STAFF COMMENTS FOR PLANNING COMMISSION

**SCHEM. DEV. PLAN: SDP-06-004 & Z-304
REZONING APP.**

TITLE: FAIRFIELD AT WEST DEER PARK

SUBJECT: Staff Analysis Z-304/SDP-06-004 - These applications concern the rezoning and redevelopment of the Broadstone Apartments, located at the intersection of MD 355 and West Deer Park Road. Z-304 is an application to rezone 14.157 acres of land from the existing R-20 (medium density residential) Zone to the CD (corridor development) Zone, in accordance with §24-196 (map amendments) and §24-160G.6 (Procedure for application and approval) of the City Code. SDP-06-004 is an application requesting the redevelopment of the Broadstone Apartments. The proposed plan includes 334 multiple-family units, 53 town homes, and 28 two-over-two units.

Exhibit 116

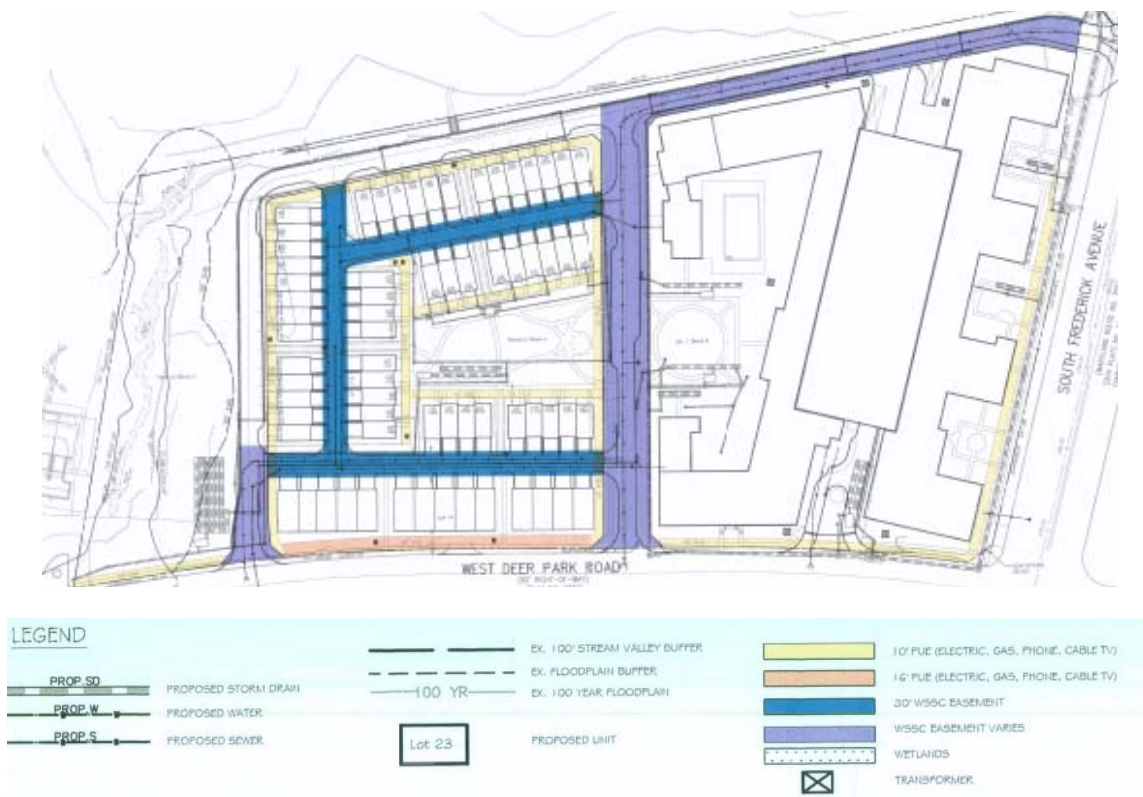
A concept utility plan has been submitted as part of this SDP application.⁶ The plan delineates the Public Utility Easements (PUEs) to be used by the various entities. The plan itself has been reviewed by the Department of Public Works, Park Maintenance, & Engineering (DPWPM&E), PEPCO, Verizon, and Washington Gas. Representatives of the various utilities have submitted to Director Arnoult, letters of satisfaction with this level of design.⁷ Coordination with the various utility companies will continue when this project enters final design phase.

8. Applicant to work with City staff and Montgomery County Ride-On regarding the review and approval of all bus shelter locations;
9. The final utility plan, including the undergrounding of utilities along West Deer Park Road, shall be revised and approved by DPWPM&E and receive final approval letters from appropriate utility agencies including, but not limited to, Washington Gas, PEPCO, Verizon, and WSSC prior to the issuance of Public Works permits for work within the West Deer Park Road right of way;

Diagram of entrance movements into the site
Exhibit 138

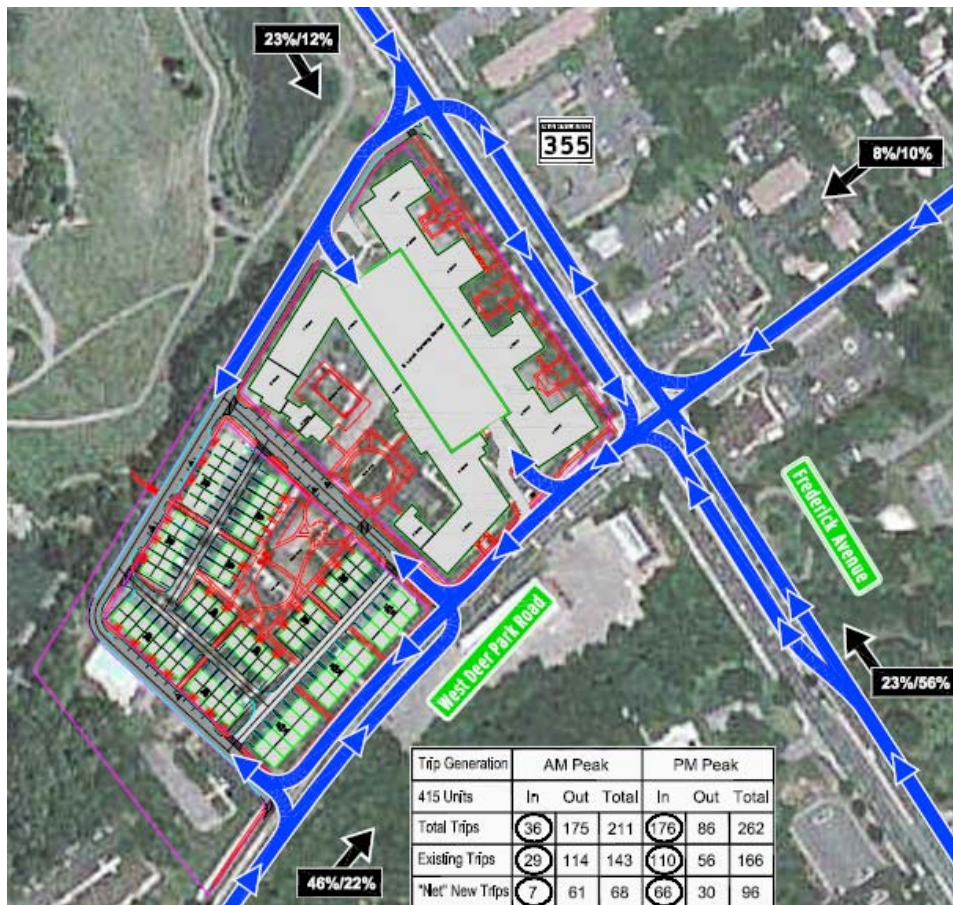
Although the traffic analysis showed no appreciable impacts¹⁰, the Planning Commission and City Council raised concerns during the joint work session, held February 12, 2007, as to the distribution of traffic impacts as they relate to the various site access points and in particular the West Deer Park-MD 355 intersection. There are currently three (3) points of full movement access into the site from West Deer Park Road. The proposed plan retains these three (3) access points, but shifts them further west to minimize stacking issues at the MD 355 intersection and makes the access point closest to MD 355 a right-in/right-out only movement. The applicant has also added an additional access point along the northern property line from MD 355. This access point will be right-in/right-out only from southbound MD 355 and a left in only from northbound MD 355.

Exhibit 140

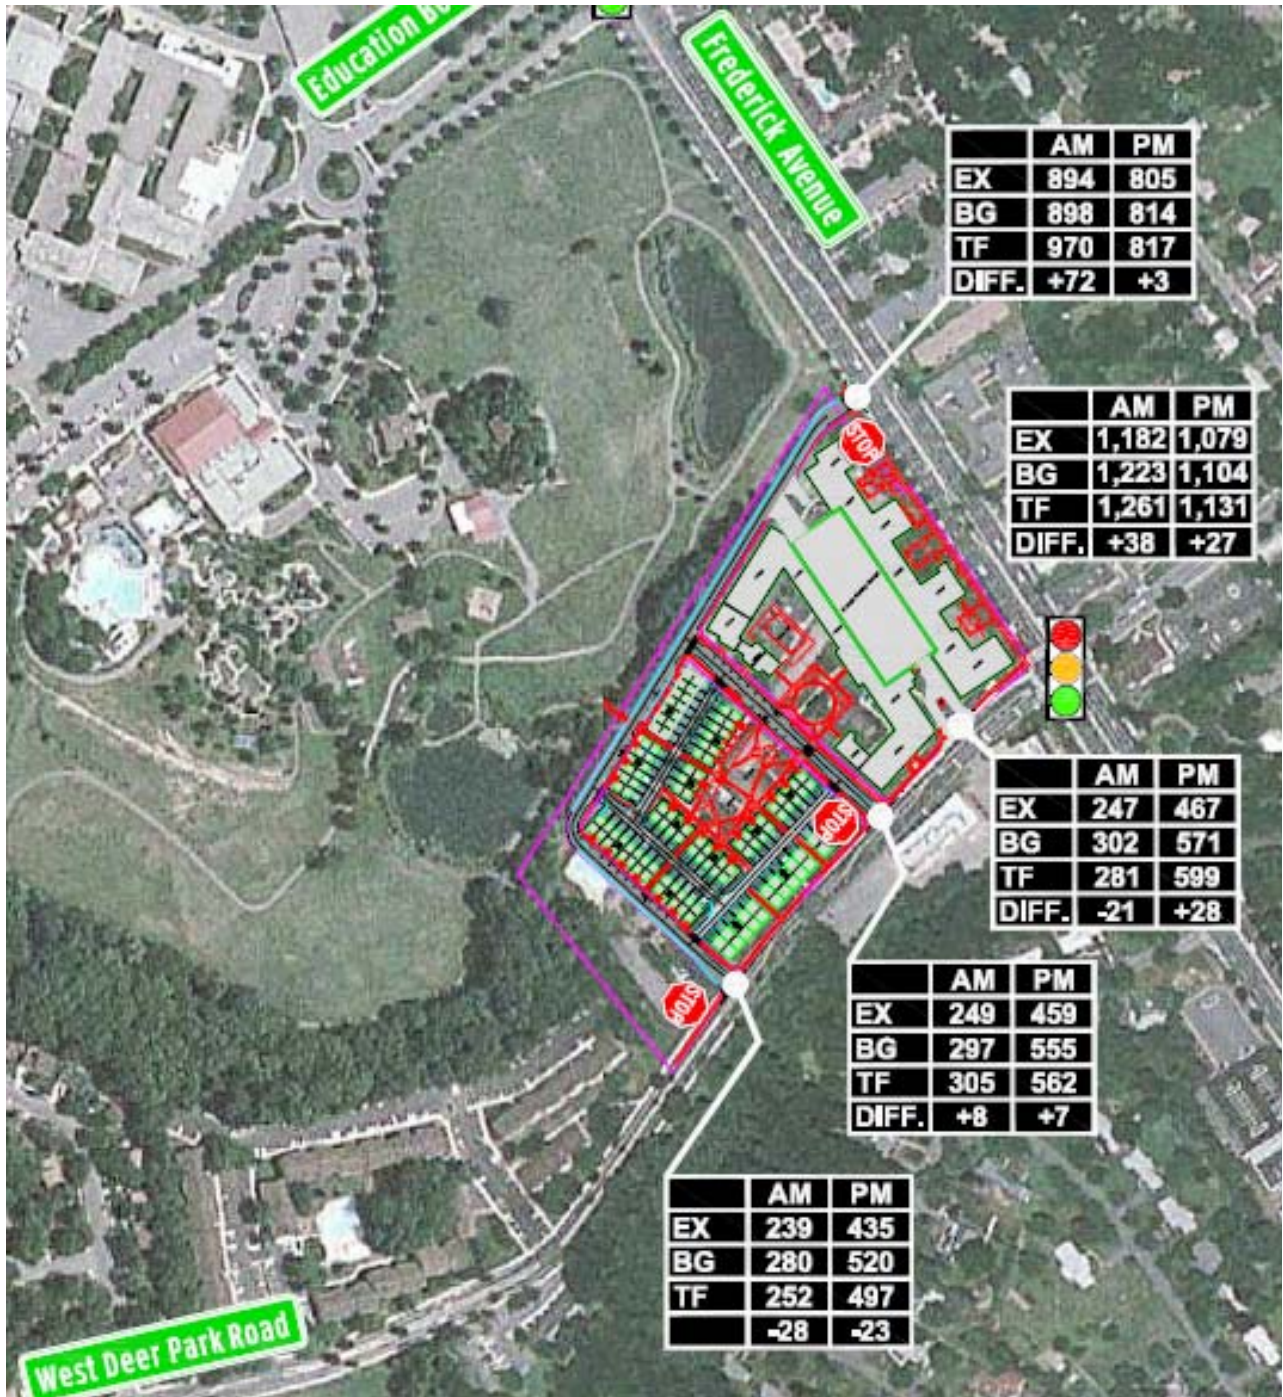
The following diagram (Ex. 140) illustrates the traffic volumes associated with the proposed redevelopment, at the various access points and the West Deer Park Road-Frederick Avenue intersection. All points show that the critical lane volumes remain below the City standard of 1450. The “BG” statistic is the future volumes with no redevelopment. The “TF” statistic is the future volumes including impacts from this project.

The largest difference between redevelopment, no redevelopment volume impacts will occur at the access point off MD 355. An additional 72 vehicles will be added in the AM to the lanes above what would occur with no redevelopment. It should be noted that the volume along MD 355 at the West Deer Park intersection only increases by 38 vehicles in the AM and 27 vehicles in the PM, with the proposed plan.

A major concern voiced during the work session concerned the intersection of West Deer Park at MD 355. The diagram illustrates that in the AM there will actually be a decline of 21 vehicles at this point. This is a result of that access point having limited movements. Not being able to perform a left movement from the parking garage onto West Deer Park redistributes those vehicles to the remaining access points, with the exit onto MD 355 absorbing the majority. The 28 vehicle PM increase is easily facilitated by the right-in only turning movement into the garage.
